Access Compliance Report Public Rights-of-Way (Curb Ramps)

Main Street: N/A Cross Street: SIENNA_PKWY Location: SE

ADA ID: RPRK220223173243 Ramp Type: Type 6 - Directional 1 Initial Pass/Fail: Pass Overall Compliance: No Severity Score: 15

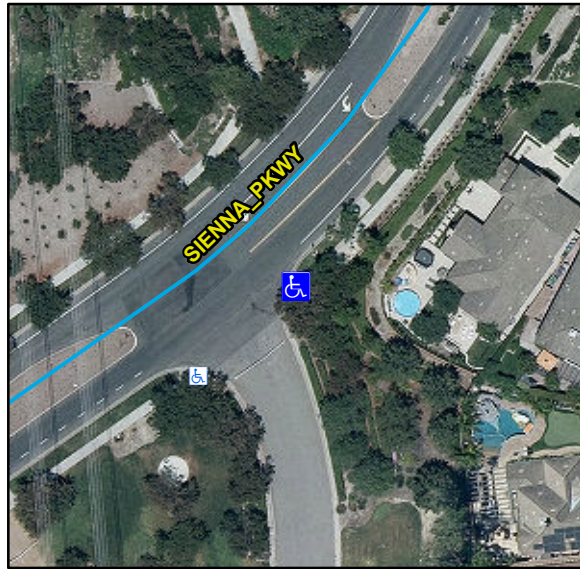
Compliance	Description	Data	Compliance	Description	Data
N/A	Ramp Length (in)	155	N/A	Flare Type LT	
Yes	Ramp Width (in)	91			Sloped
Yes	Ramp Run Slope (%)	7.7	N/A	Flare Slope LT (%)	N/A
Yes	Ramp Cross Slope (%)	1.4	N/A	Flare Traversable LT	No
No	Grade Break	No	Yes	Flare Type RT	
N/A	Grade Break Slope (%)	N/A			Curbed2
N/A	Grade Break Cross Slope (%)	N/A	N/A	Flare Slope RT (%)	N/A
	Addl Para Ramp Left?	No	N/A	Flare Traversable RT	N/A
	Addl Para Ramp Right?	No	No	DWS Provided	No
N/A	Landing Present	Yes	N/A	DWS Contrast	N/A
Yes	Landing Length (in)	83	N/A	DWS Length (in)	N/A
Yes	Landing Width (in)	48	N/A	DWS Full Width	N/A
Yes	Landing Run Slope (%)	1.2		DWS Offset Type	N/A
Yes	Landing Cross Slope (%)	1.4	N/A	DWS Left Offset (in)	N/A
N/A	Landing Movement Obstructed?	No	N/A	DWS Right Offset (in)	N/A
	Landing Movement Type	N/A			
N/A	Landing Shared	No			
N/A	Marked Crosswalk 1	No	N/A	Clear Space	N/A
	Crossing 1 Direction	SW	N/A	Clear Space To Crosswalk (in)	N/A

Marked Crosswalk 1 Width (in)	N/A			
N/A	Ramp Inside Crosswalk 1	N/A			
	Crossing 1 Slope (%)	0.4			
	Crossing 1 Cross Slope (%)	1.3			
No	Gutter Ponding	Yes	Yes	Curb Slope	1.6
Yes	Gutter Lip Height (in)	0		Road Run Slope (%)	N/A
No	Gutter Run Slope (%)	9.3		Road Cross Slope (%)	N/A
Yes	Gutter Cross Slope (%)	0.1		Parallel Ramp Side	N/A
Yes	Overall Surface Condition	Acceptable	Yes	Perp Joint Present	Yes
	Cross Gutter Present?	No		Spandrel Present?	No
	Replace Cross Gutter?	N/A		Replace Spandrel?	N/A

Remove & Replace Entire Ramp. Remove & Replace Gutter.

R304.5.2, R305, R302.7, R304.5.4, STD 1115
